V2500-A5/D5 SERIES PROPULSION SYSTEM NON-MODIFICATION SERVICE BULLETIN

This document transmits the Revision 1 of Non-Modification Service Bulletin V2500-ENG-72-0618.

NON-MODIFICATION SERVICE BULLETIN – ENGINE – HIGH PRESSURE (HP) COMPRESSOR – ONE TIME
INSPECTION OF STAGE 3 ROTOR BLADE CLAPPERS

High Pressure Compressor (HPC) Stage 3 rotor Blades
Figure 1

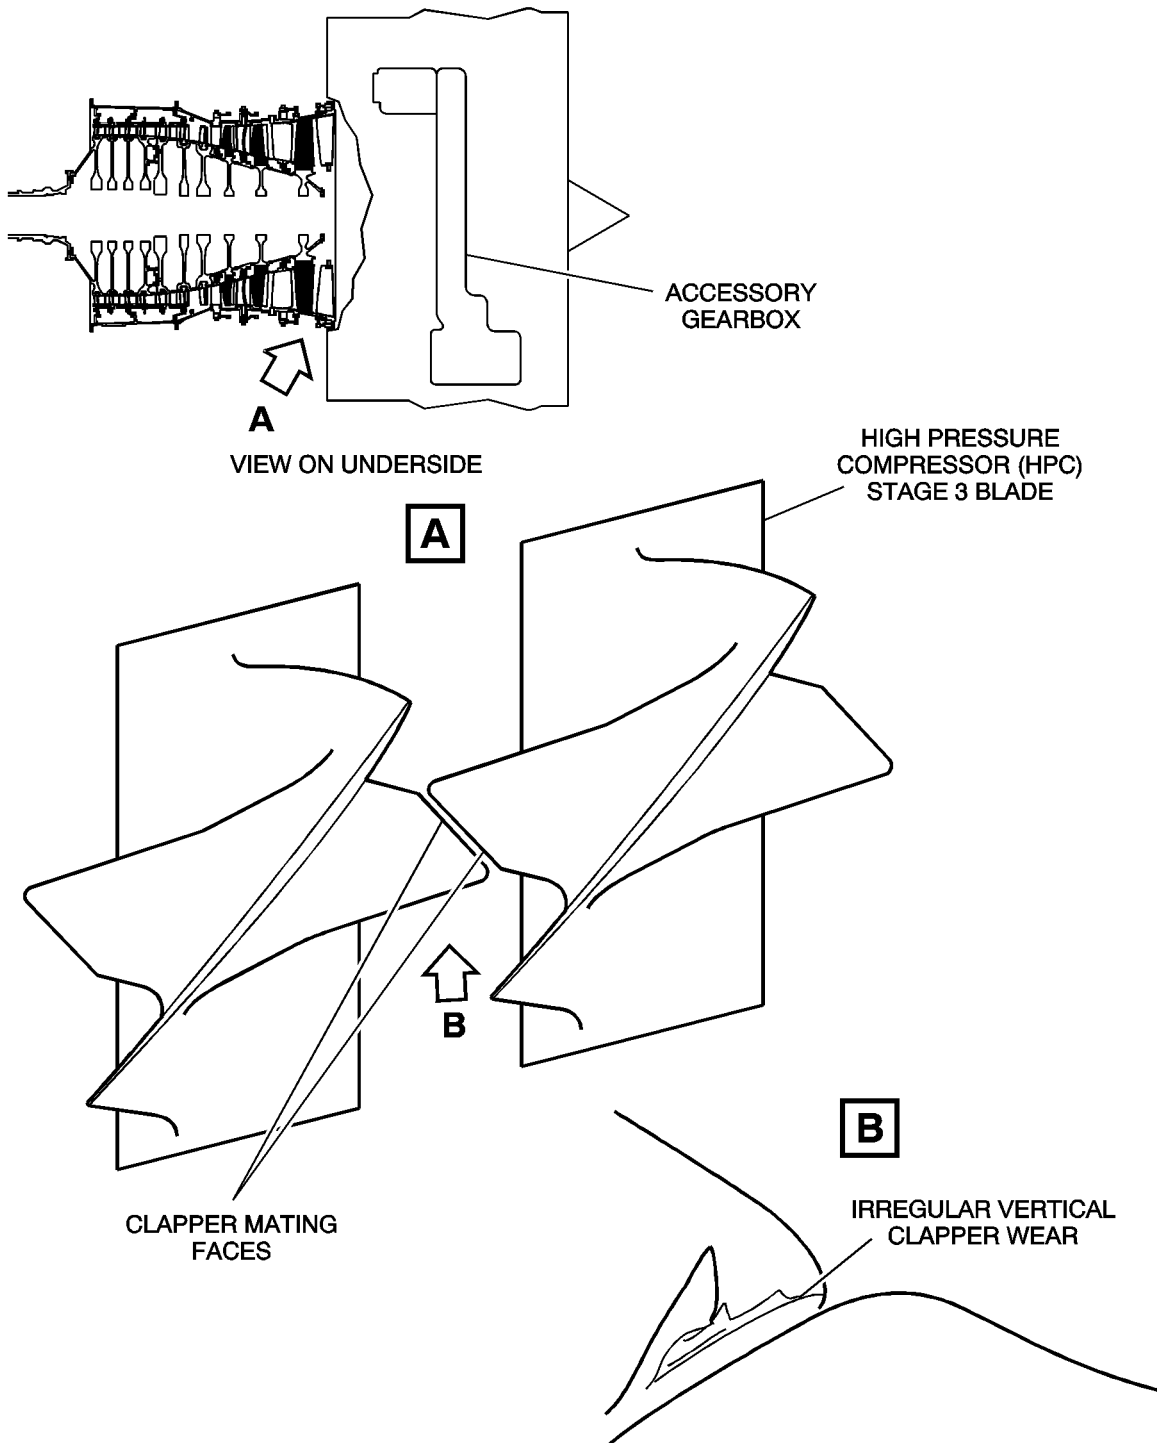
(2) Compare the results with Figure 1.

(b) Irregular vertical wear as shown in Figure 1 – Reject within 100 cycles.

Refer to the Engine Manual, Chapter 72-00-00, PB801/TASK 72-00-00-200-002-002.
- (2) Compare the results with Figure 1.
- (3) Accept and reject criteria:
 - (a) No evidence of wear – Accept.
 - (b) Irregular vertical wear as shown in Figure 1 – Reject.
